NASA/TM-2013-217996 (Corrected Copy)
NESC-RP-12-00768

Structural Analysis Peer Review for the Static Display of the Orbiter Atlantis at the Kennedy Space Center Visitors Center

**Structural Analysis Peer Review
of the
Kennedy Space Center Visitors Center Orbiter
Atlantis Static Display**

Figure 7.1-1. Orbiter Attach Point Compliance (Weight and Reaction Loads)

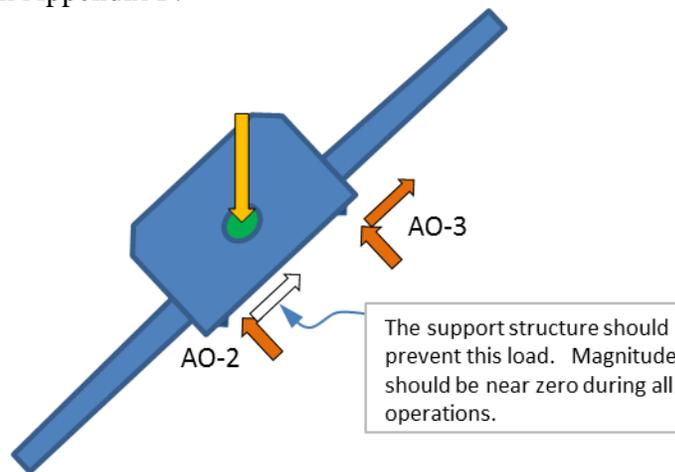
NESC Concern (Roscoe, August 17): The orbiter installation was to be performed in November and without environmental control (i.e., without the building's roof installed). Given a change in temperature event during installation or while on display, differential thermal expansion between the orbiter and the support structure drove the need for compliance between the two articles. The DNC calculations (Appendix E) predicted forces at the AO joints with perfectly compliant (i.e., zero stiffness) support structure. The DNC used Fluorogold[®] bearing elements to add

BRPH Response (Paquette, August 20): “We have been looking at the concerns about differential thermal expansion between the Orbiter and the Orbiter Support frame and had the following response.

- b. We have also added high capacity slide bearings at the edges of the shear lugs at the spacers to reduce friction at AO3 and AO1 in the X_o direction from the Y_o loads and at AO2 in the Z_o direction and we have considered the breakaway friction at the edge slide bearings in our calculations as well.

bearing area to increase pressure load to the minimum recommended, added slide bearings to the shear lugs, removed post-installation bolt torque, and calculated predicted max break-away shear loads due to thermal expansion). The contractor team could have (or may have) tried to determine the structural compliance between AO-2 and AO-3 for the small thermal expansion difference. However, the 16,300-lb limit may have been too low for the Support Frame. Either way the bearing solution works. Once a slide bearing was introduced under AO-1, the contractor team solved the biggest threat to the thermal expansion issue. Refer to in-depth question and response discussion in Appendix F.

1. Compliance of attach points for thermal expansion

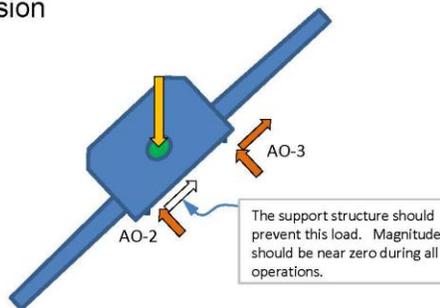
- BRPH has re-engineered their Flourogold® slide bearing design to better accommodate thermal issues as a result of NESC inquiries:
 - Contacted Flourogold® to estimate break-away friction
 - Reduced bearing area to increase pressure load to minimum recommended (overcomes static friction)
 - Removed post-installation bolt torque
 - Added slide bearings to side of shear lugs (effective when rotated)
 - Calculated predicted max break-away shear loads due to thermal expansion

2. Sufficient lateral stiffness of the lifting jacks

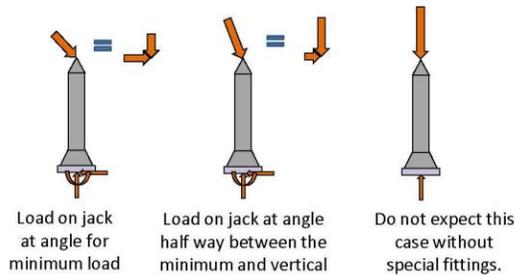
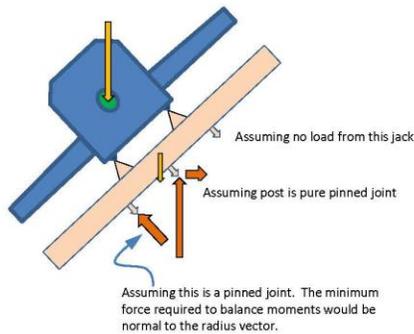
- Concern that jacks will experience a moment as the orbiter is being rotated to final position (starboard side 43 deg. down)
 - BRPH incorporating bracing, sliding tracks for jacks, and dunnage in 2" increments to control rotation.
 - Insufficient jack data to do analysis – but will demonstrate capability with testing (open work). Plan to use an orbiter mass simulator to perform pathfinder test.

3. Payload Bay Door (PLBD) Support Beam Factor of Safety (FoS)

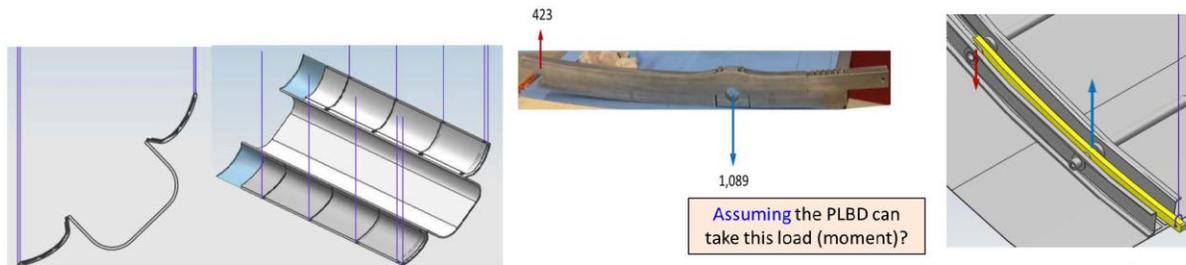
- PLBD Support Beam design was based on FoS of 2
- NESC concerned with transition of PLBDs from existing GSE to support beam & cables.
 - Weight of GSE still attached; Strongbacks make doors semi-rigid
 - Planned method to transfer load to support cables via turnbuckles
 - Should consider Support beam and cables as lifting devices during transition (NASA Standard required FoS of 5)
- USA opted to use stronger bolts and improve their analysis resulting in FOS greater than 5.

Dunnage: Drawing vs. Actual

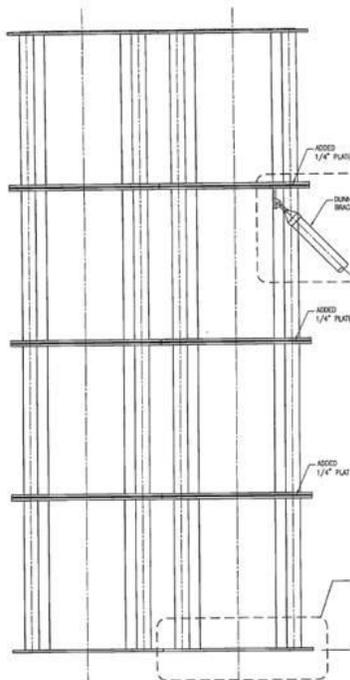
1. Without a load spreader, all the load will be transmitted to the columns under the pivot.
 - a) Flat plate will flex and not transmit loads laterally to adjacent columns
2. Drawing show identical units. Actual shows changes in pipe diameter and pipe center locations.
3. Not identified on drawing

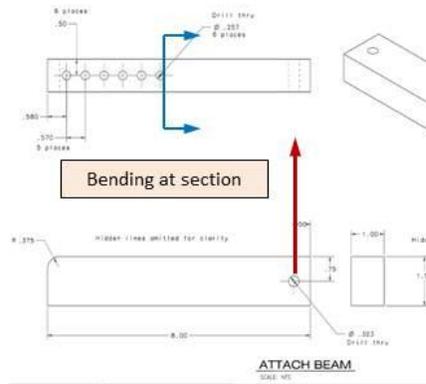
Lots of bending capacity, not a lot of bolt capacity. Consider using 3/8" bolt at end.

- Recommend modifying 1 bolt from a 1/4" to a 3/8".
Modifications:
 - Drill 1 hole bigger
 - Drill and tap 1 hole bigger
 - Acquire an extra 3/8" bolt

At: 3/8" hole Shear Tube

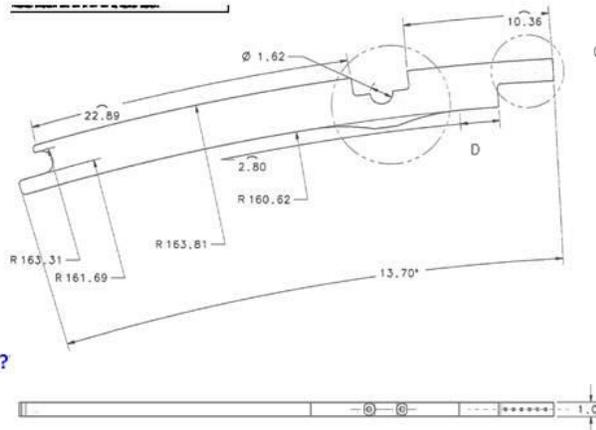
Same as in Mathcad doc. Ultimate? Note: Not concerned about stress concentrations (Kt). They are for fatigue and slight yielding, neither are a concern. FEA will pick up some Kt.
